Amendment

Claims 22-66 are pending in this application. By this Amendment, the Abstract is amended, replacement and annotated drawings sheets for Figures 2 and 3 are provided and claims 22, 36, 40, 54, 56, 58 and 66 are amended. Claims 1-21 were previously cancelled without prejudice or disclaimer. Reconsideration in view of the above amendments and following remarks is respectfully requested.

Title: HIGH EFFICIENCY LIQUID OXYGEN SYSTEM Applicants: Mark FRYE, et al. Application No.: 10/658,793 Attorney Docket: 82058-0013 ANNOTATED SHEET

FIG. 2

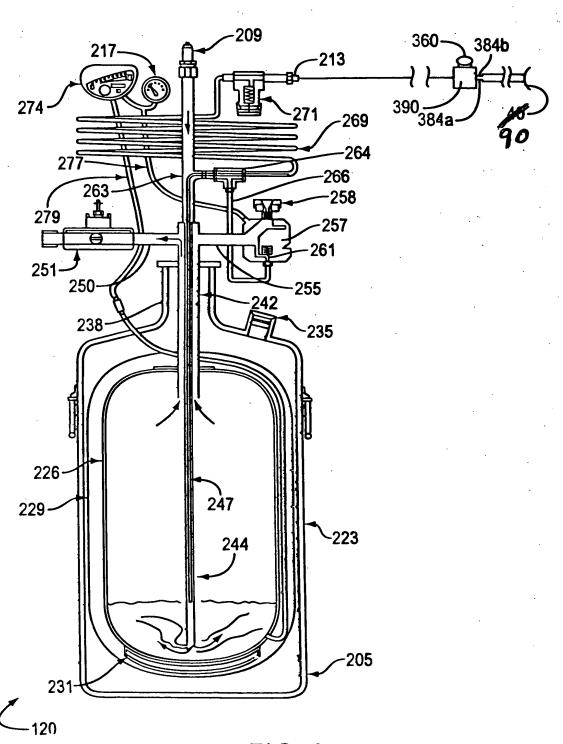
The attached sheets of drawings include changes to Figures 2 and 3. These sheets replace previously submitted Figures 2 and 3.

The Office Action notes that Figures 2 and 3 were previously marked up, but that replacement sheets have not been submitted. By this Amendment, replacements sheets for Figures 2 and 3 are provided along with annotated sheets showing the changes. Figure 2 was previously amended to change to legend 40 to 90 in order to conform the drawing to the specification. Likewise, in Figure 3, the legend 352 was changed to 382 in order to conform the drawing to the specification. It is respectfully submitted that no new matter is introduced, but that annotated sheet and replacements sheets are provided to reflect these amendments.
